ADDENDUM NO.: 003

DATE OF ADDENDUM: December 17, 2015

**Combined Major Utility Replacement
Hammonasset Beach State Park
1288 Boston Post Road
Madison, CT**

BI-T-605

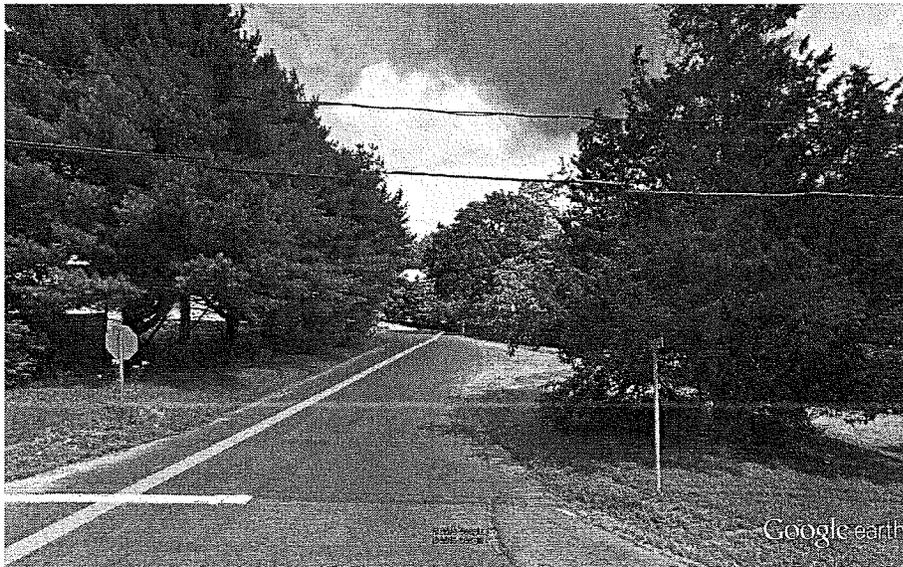
Q: Please provide a legible plan of the route that the 8" water main is taking after it crosses Route 1 on Plan Sheet SU130 in the upper left hand corner. Is it passing through a wooded area?

A: The Connector Road is a paved road (see photo below) to the Signal Hill Road. The new water main is within the pavement of Connector Road.
